# STATE OF OHIO DEPARTMENT OF TRANSPORTATION

## GRE-68-12.65

### BUILDABLE UNIT #3 AND #4

**INTERIM SUBMITTAL  
DATE: 02/17/2025**

P.22 P.83

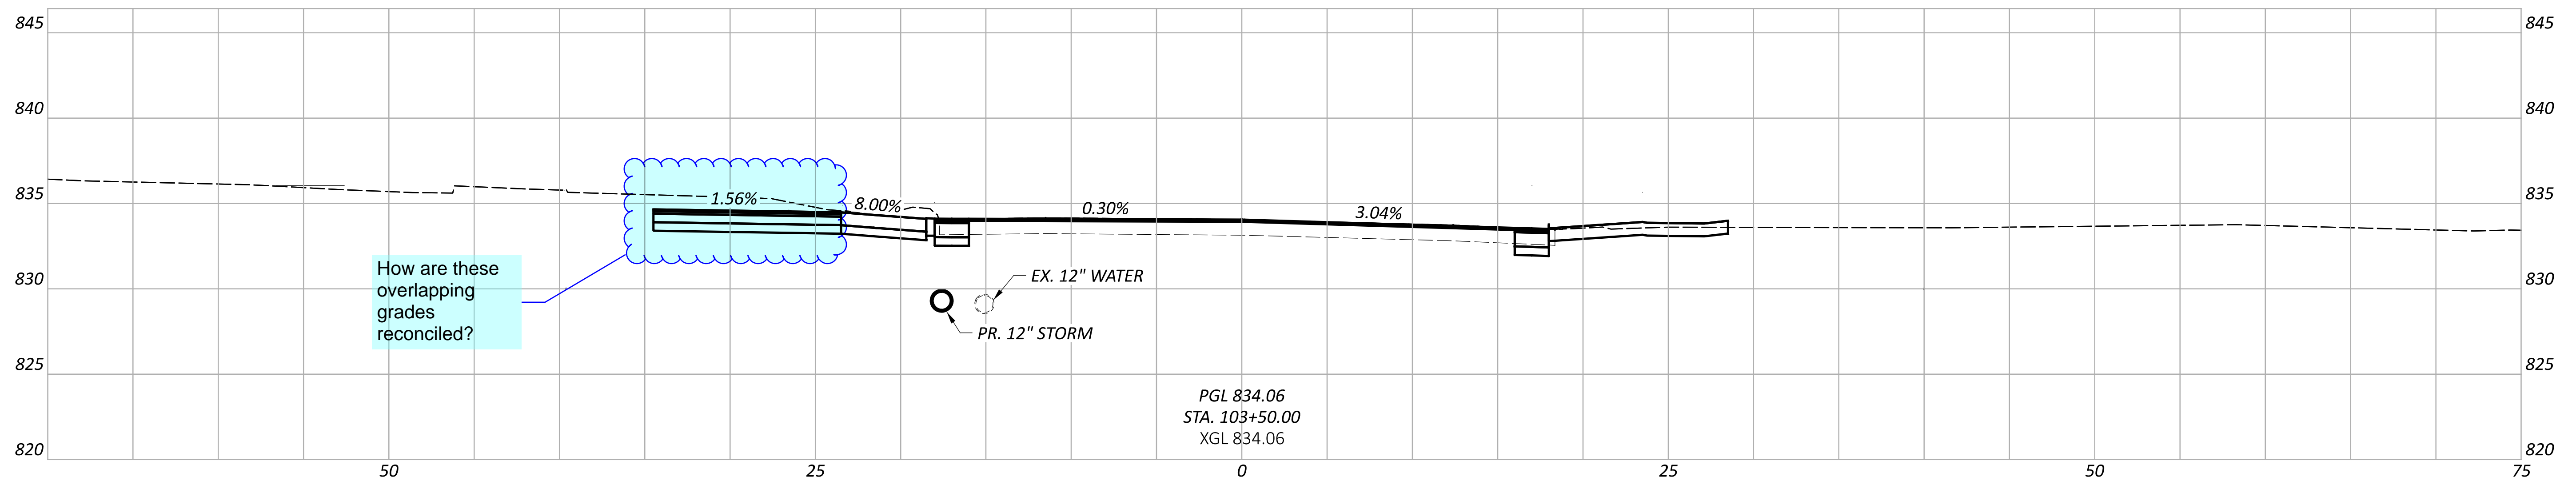
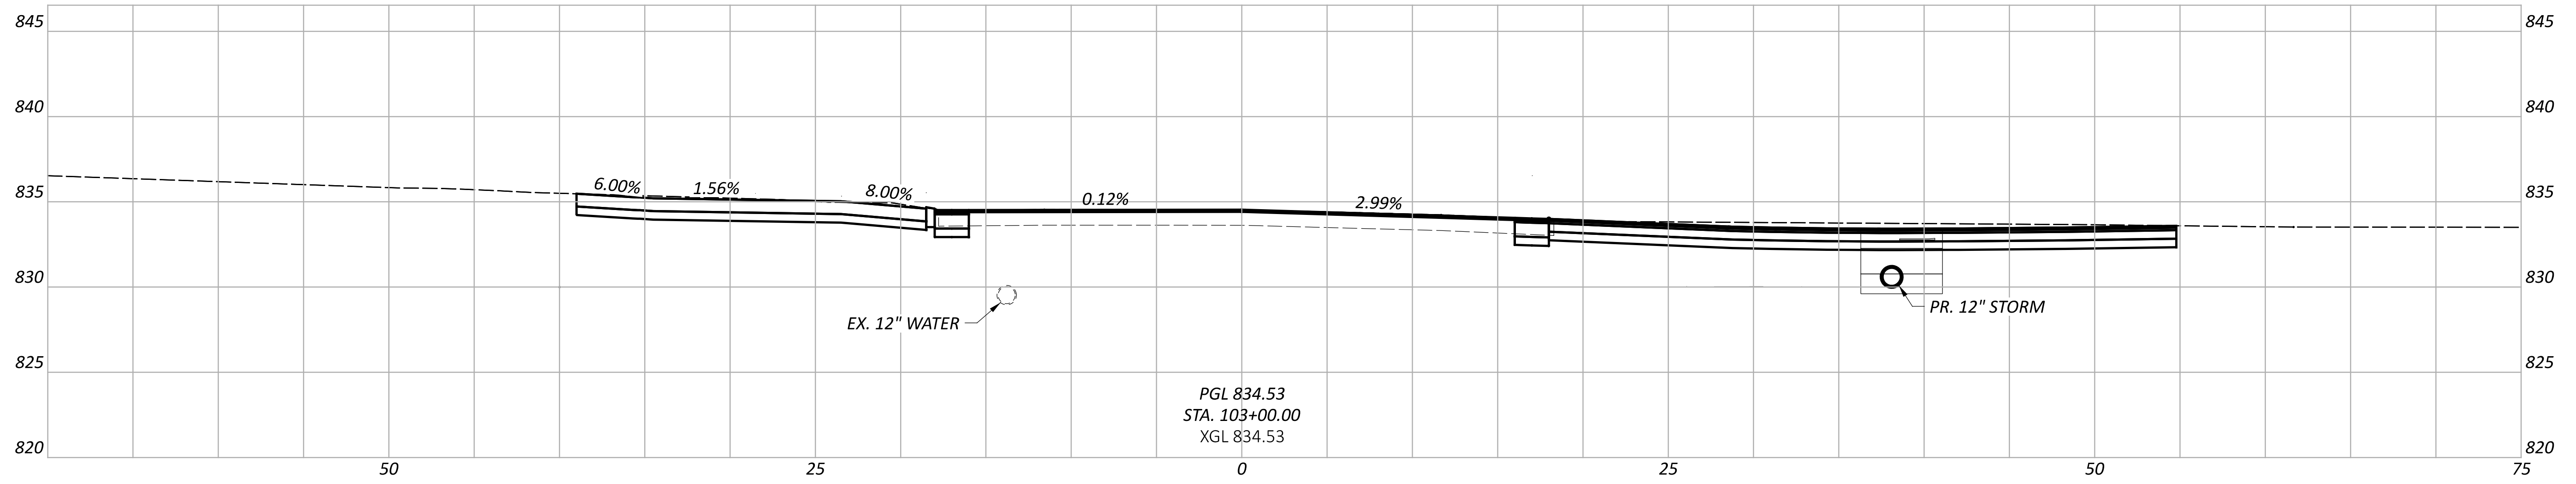
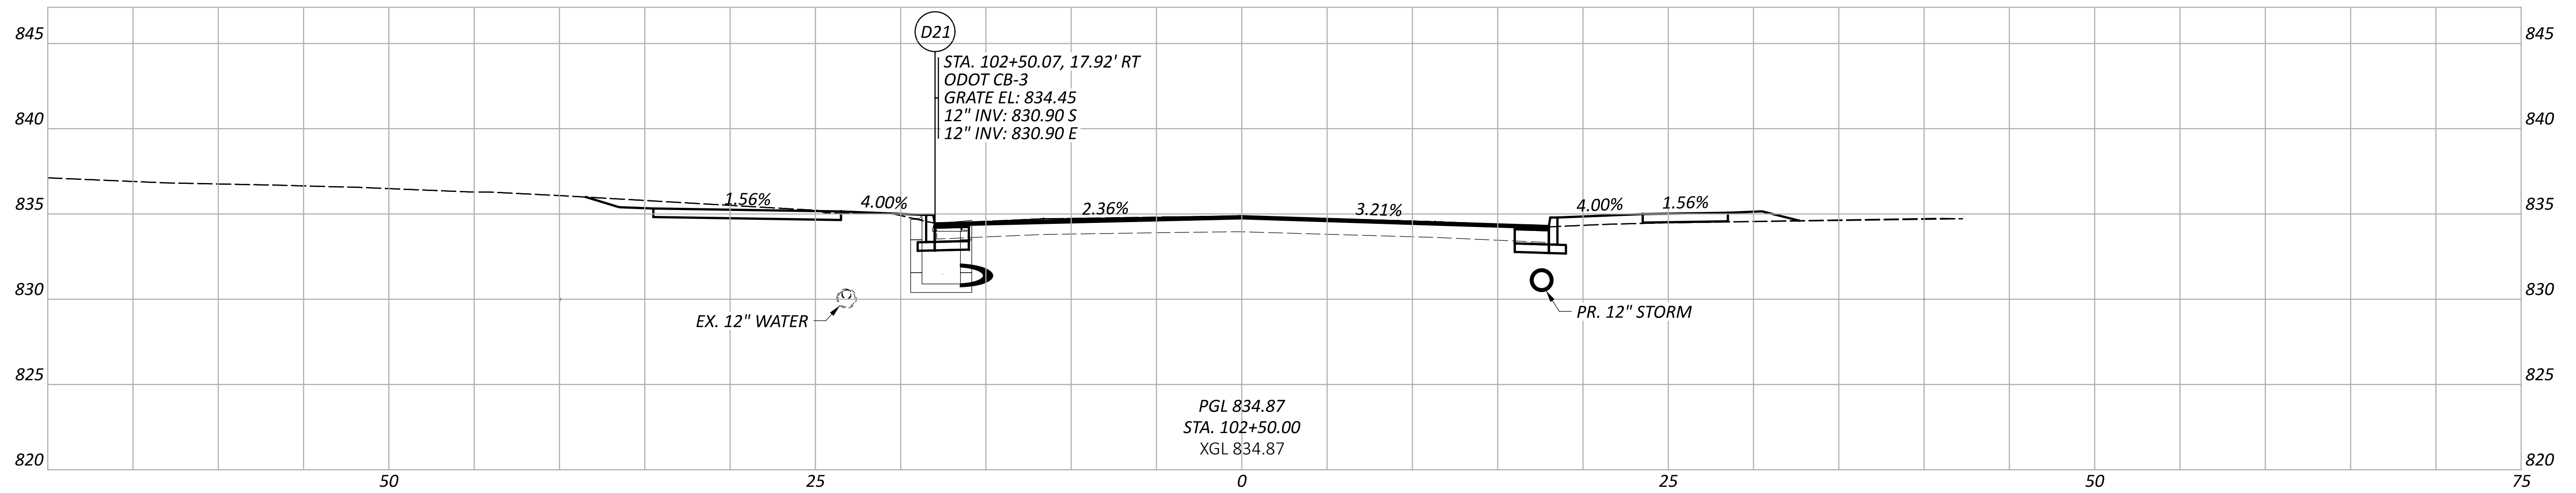
How are these overlapping grades reconciled?

PLAN AND PROFILE - RAMP  
 STA. 0+00.00 TO STA. 5+50.00

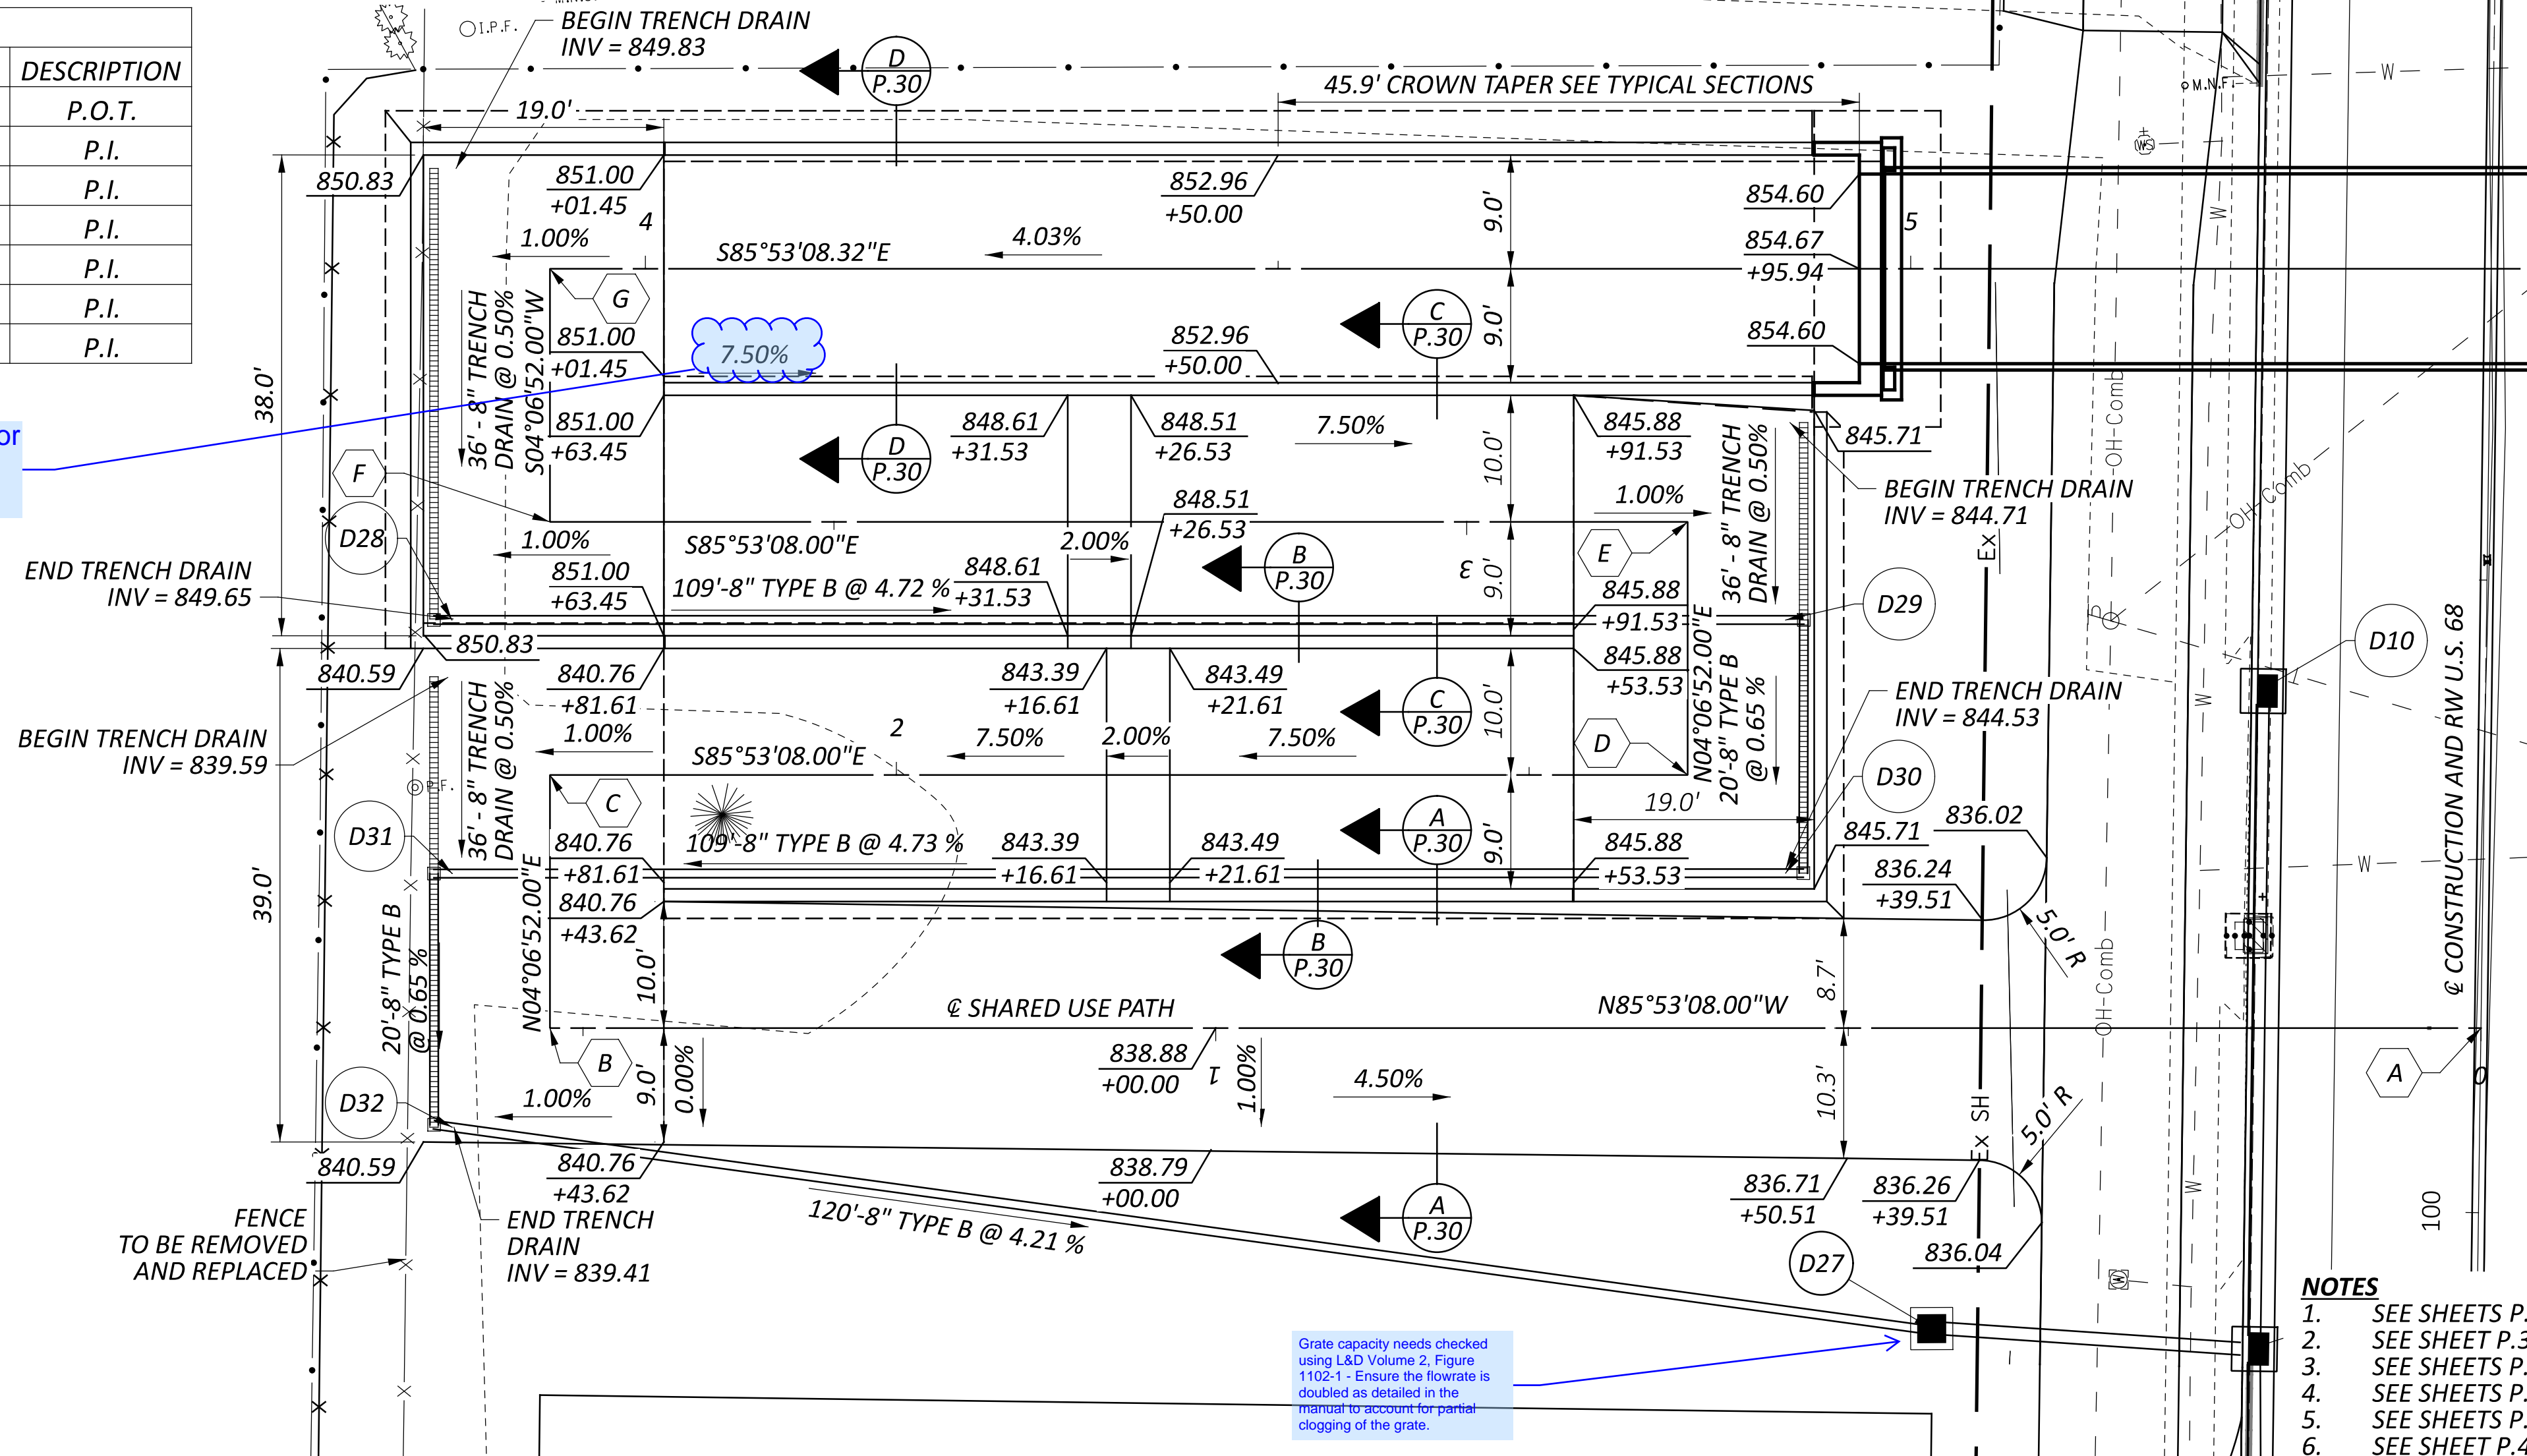
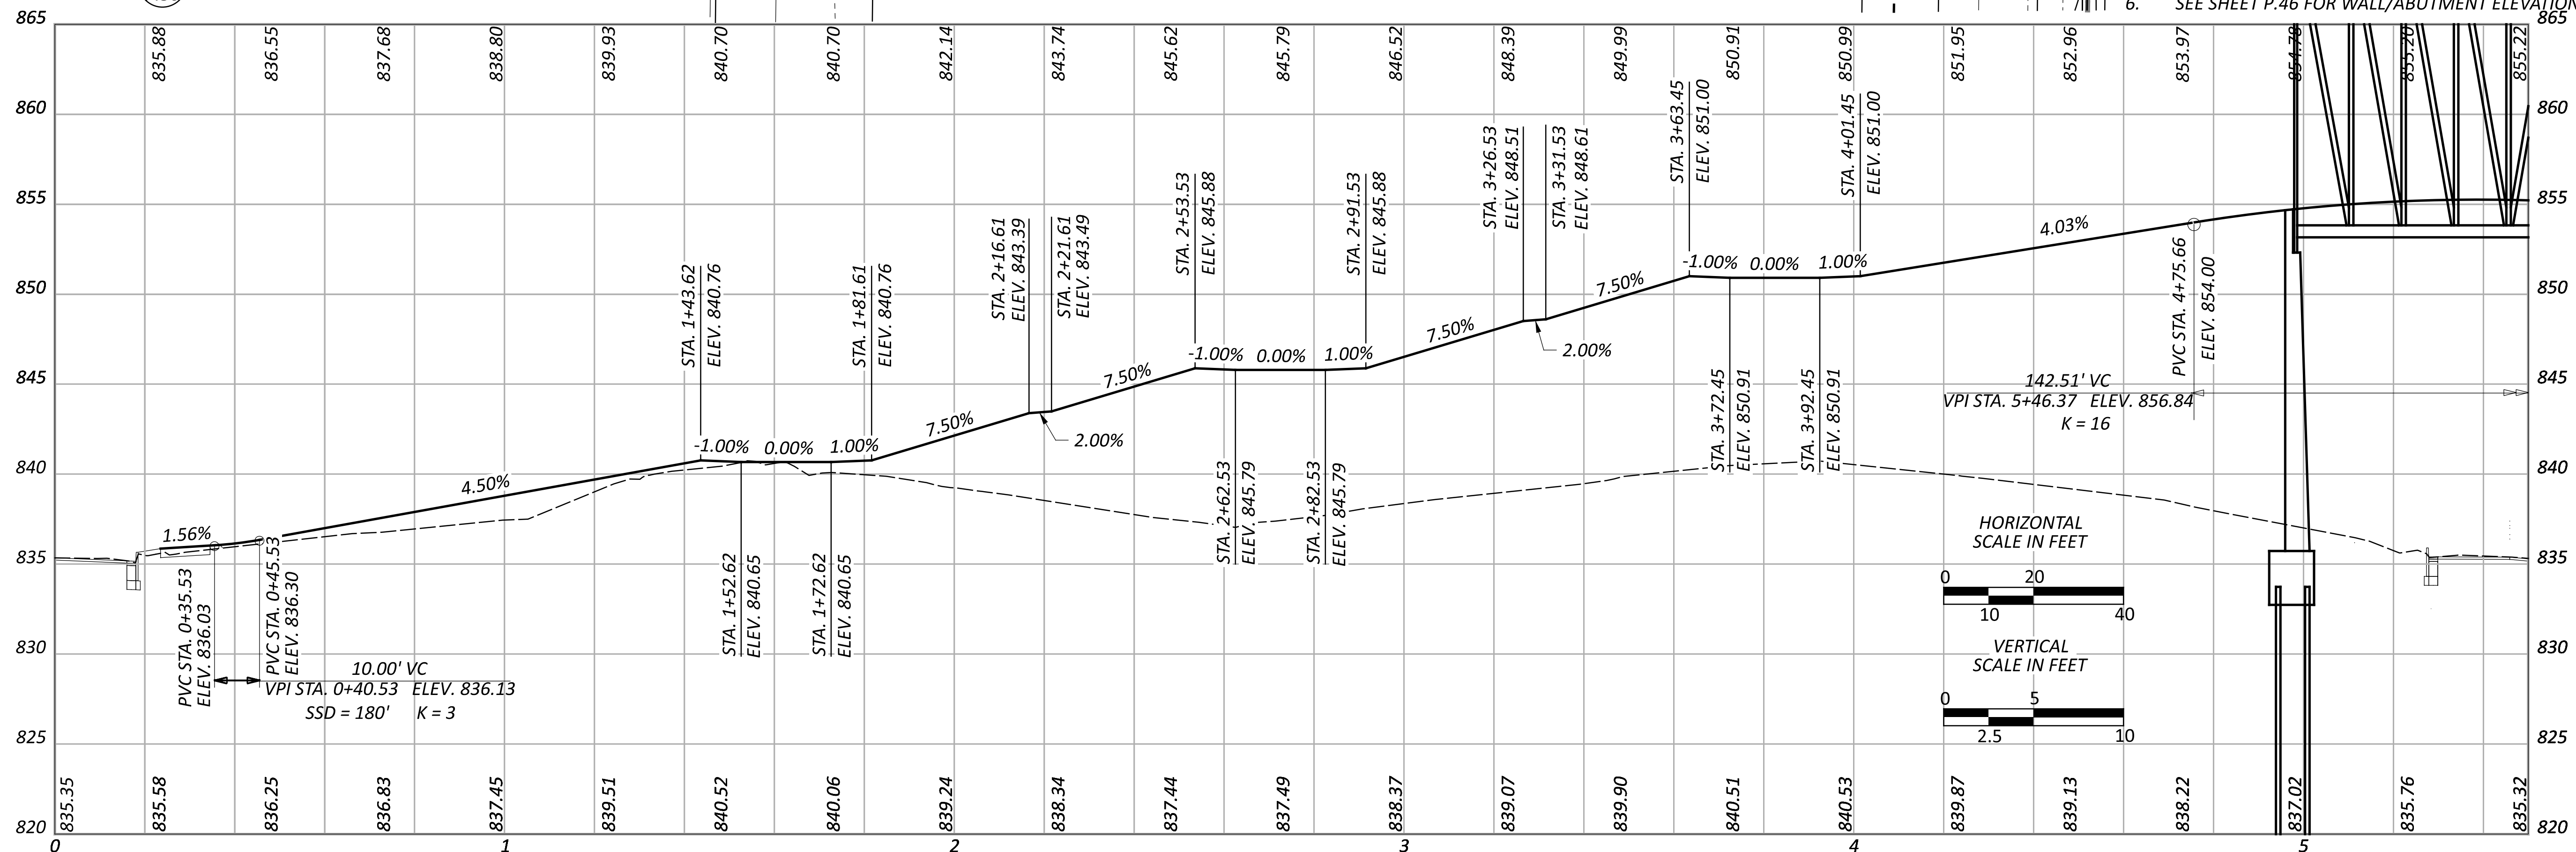
Is this 7.5% for the wall/rail grade?
